Memorandum

Subject: Change Memo - Agenda Item 7A; 80 Clear Creek Road Viewshed Protection Program
Application P22-00182-VIEW & Road and Street Standards Exception

PROJECT CLOUD

VIEWSHED

1 PARTIAL SITE PLAN
1" = 30'-0"

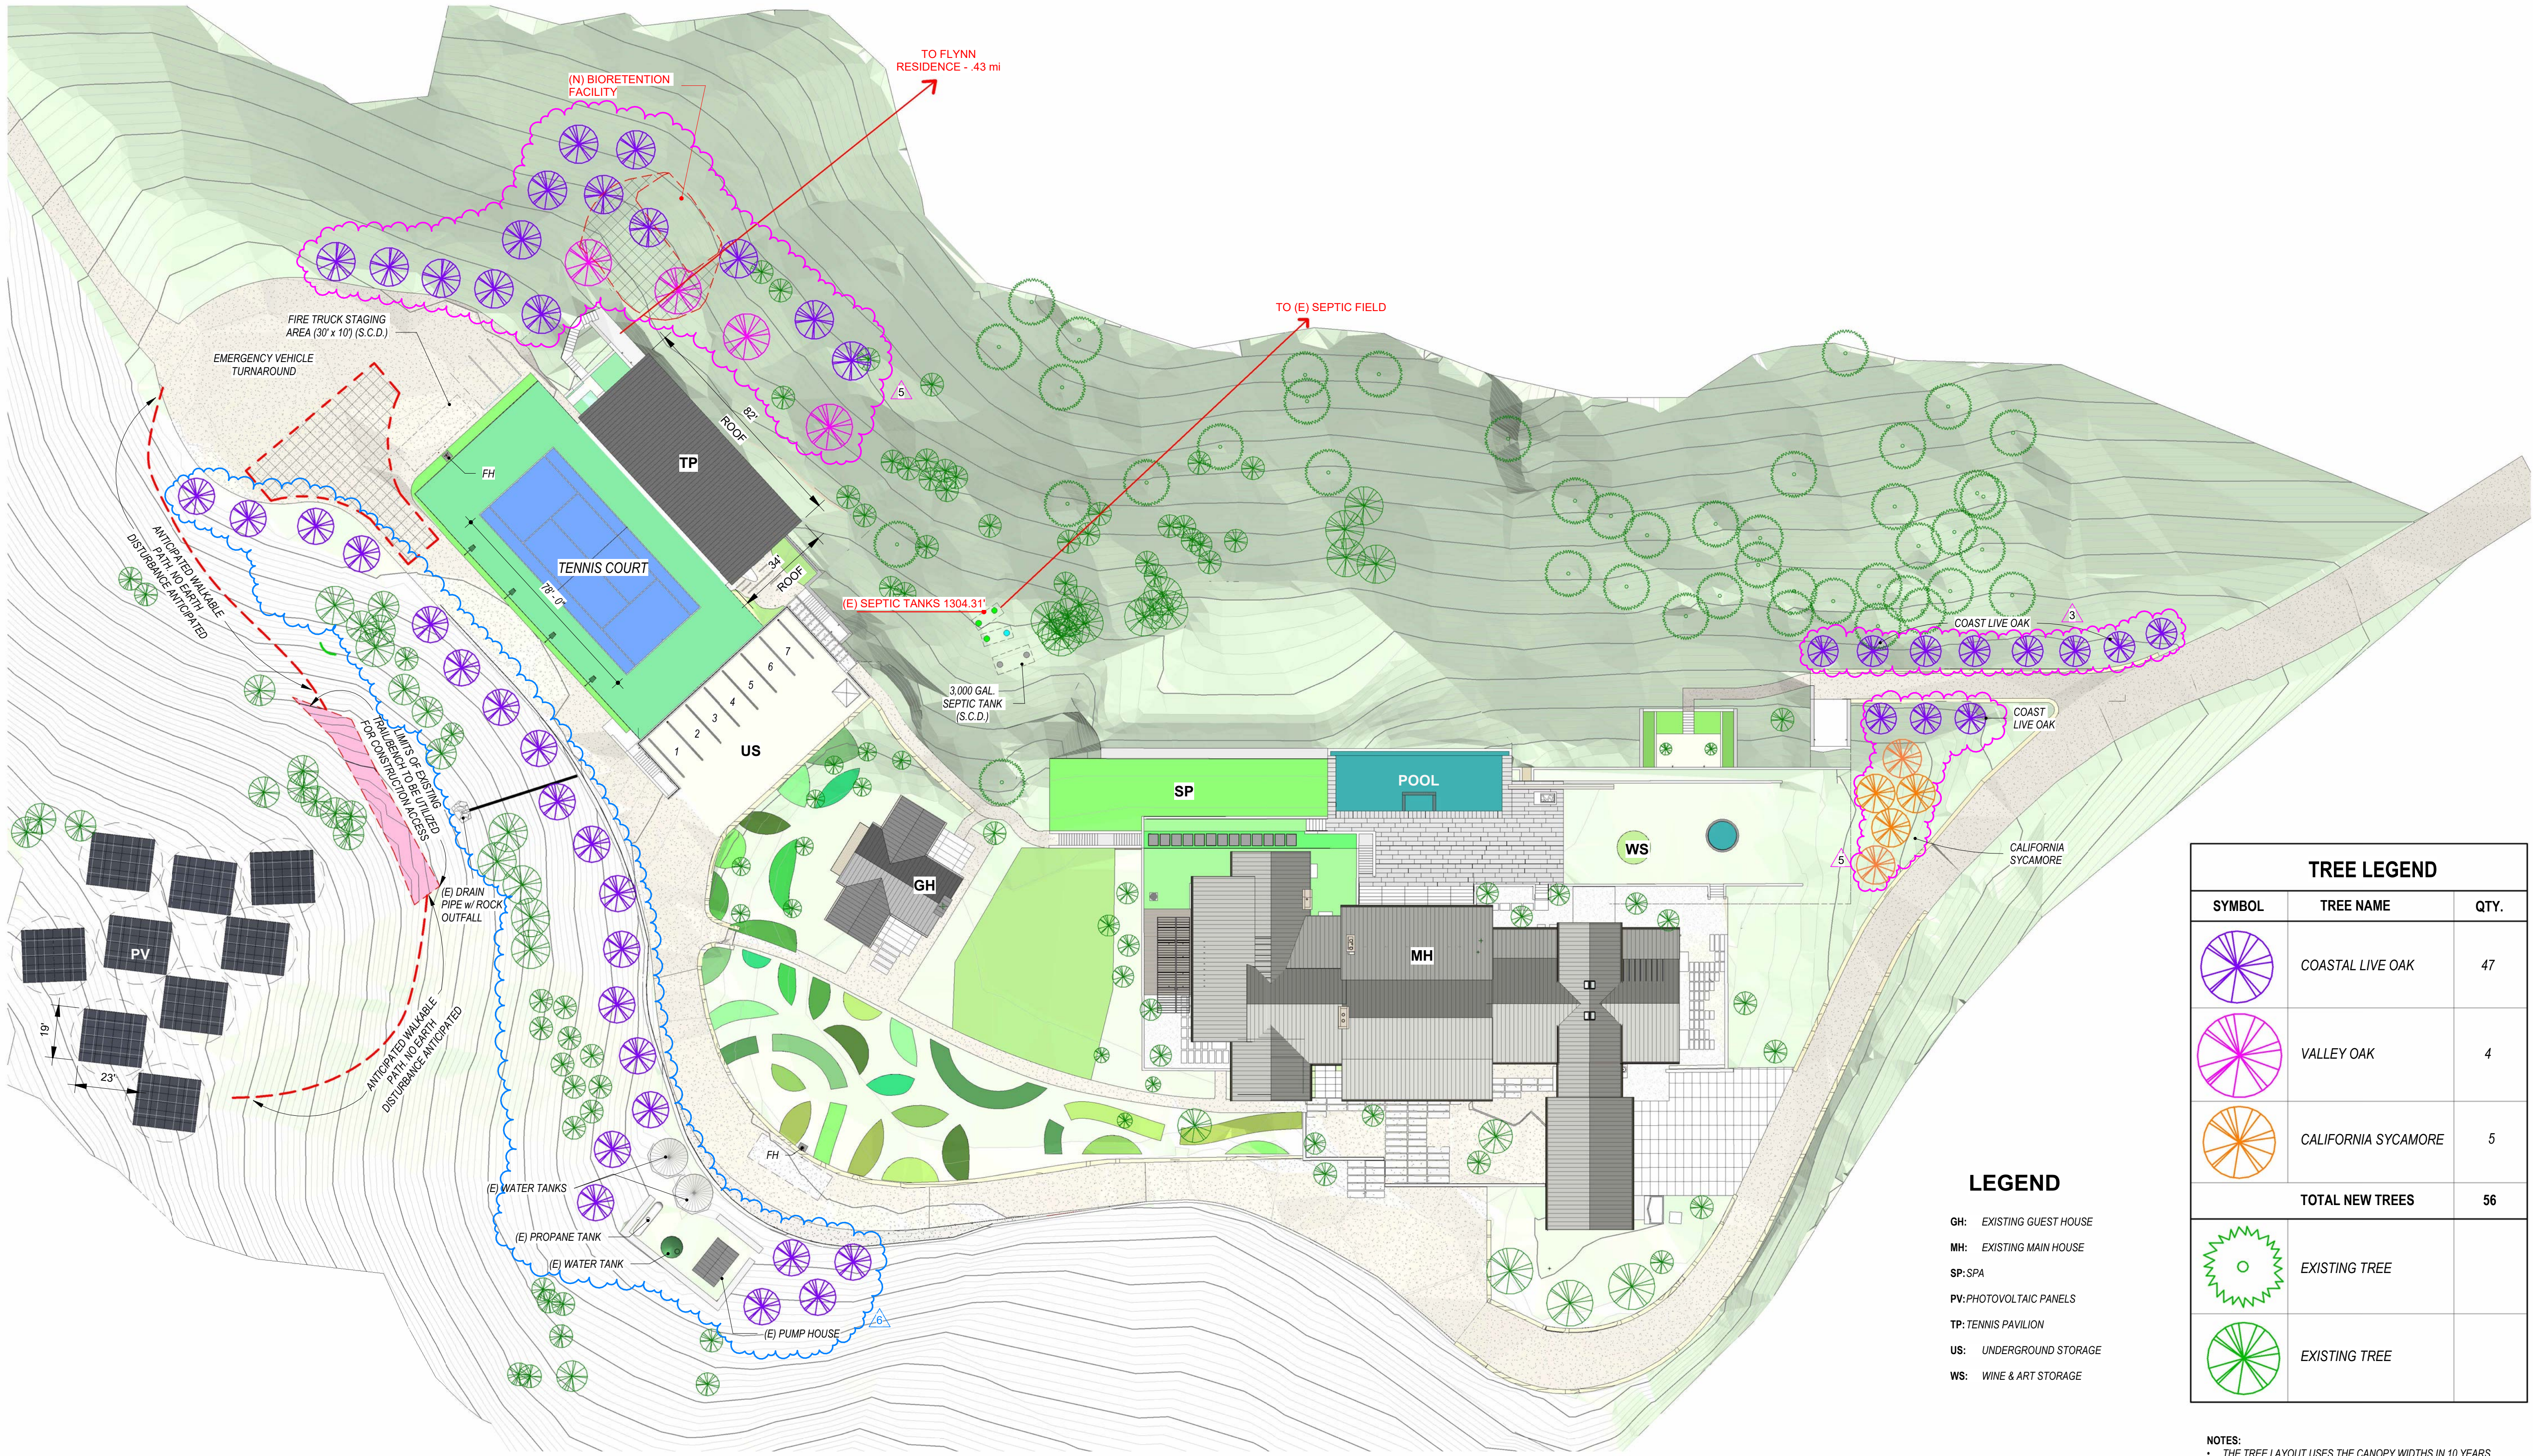
The applicant has submitted revised graphics regarding tree plantings for landscape screening. Prior revised graphics focused on tree planting locations (including new species) and spacing for screening landscape along the eastern viewshed of the Tennis Pavilion. The revised graphics did not consider spacing along the western viewshed screening landscape, where the applicant also intends to replace the proposed Interior Live Oak species (30% of the tree plantings intended for that screening area) with Coast Live Oak. Based upon recommendations by the project's Landscape Architect for spacing between plantings, the applicant has submitted revised graphics for tree screening across the entire project. Based upon the graphics submitted, the accurate intended total number of tree plantings intended to screen the project is 56.

Should the commission approve, or approve with modifications, Viewshed Protection Program application P22-00182-VIEW, the commission should reference the revised graphics and tree plantings in this change memo when making a motion.
